**Urgent Field Safety Notice**  
**WiSE CRT Electrode-Catheter Model 1000**

**Urgent Field Safety Notice (FSN)**  
**WiSE CRT Electrode-Catheter Model 1000**  
**Receiver Electrode Detachment Issue**

**Appendix B: Amended Electrode Delivery System Instructions for Use**

*Figure 1: Electrode Detached - Orange Indicator Circle (boss) at Proximal Side of Handle*

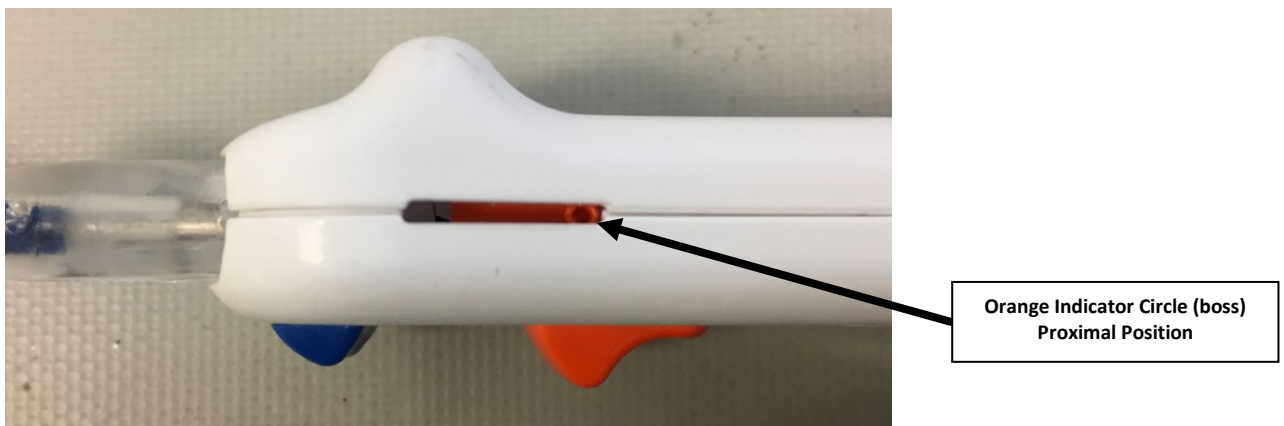
**However, in the event that, after following the required IFU step of pushing the detach button (orange button) forward, there is no indication of detachment (viewing port color did not change from green to orange) and it is uncertain whether or not the Electrode has successfully detached, you may either:**

- **Follow the steps in the IFU to remove the Electrode Delivery System; or**
  - **Complete the following sequence of steps to visually assess detachment, and if indicated, perform a manual Electrode detachment.**
1. Visual Assessment: On the catheter handle, examine the side port and determine the position of the orange circle (also referred to as “boss”). If it is fully proximal, as shown below in Figure 1, indicating that the Electrode is detached, proceed to release the electrode from the sheath per the IFU. If the “boss” is not proximal (as shown in Figure 2), indicating that the Electrode is not detached, proceed to step 2 below, Manual Detach

*Figure 3: Electrode Manual Release*

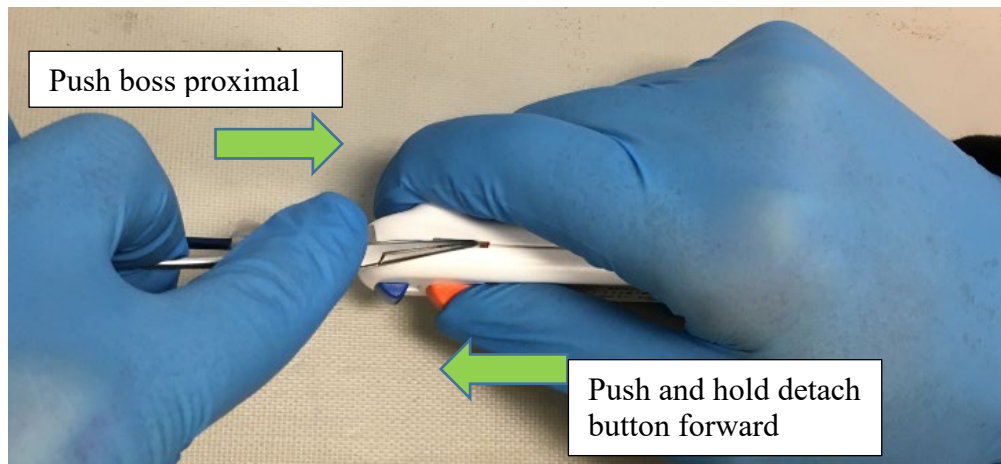
2. Manual Detach: While maintaining the position of the Electrode and Delivery Sheath, as shown below in **Figure 3**, push and hold the orange detach button forward and at the same time insert a tool like a forceps or similar into the side port to engage the “boss” (orange circle), and slide the “boss” proximal. The distal tip of the tool should be approximately 1mm diameter and 7mm long to engage the boss feature. Afterwards, release detach button and verify the orange circle (boss) remains fully proximal. If proximal (as shown above in Figure 1), proceed to release the electrode from the sheath per the IFU. If the Orange Indicator Boss is not proximal (as shown in Figure 2, follow the steps in the IFU to remove the Electrode Delivery System.
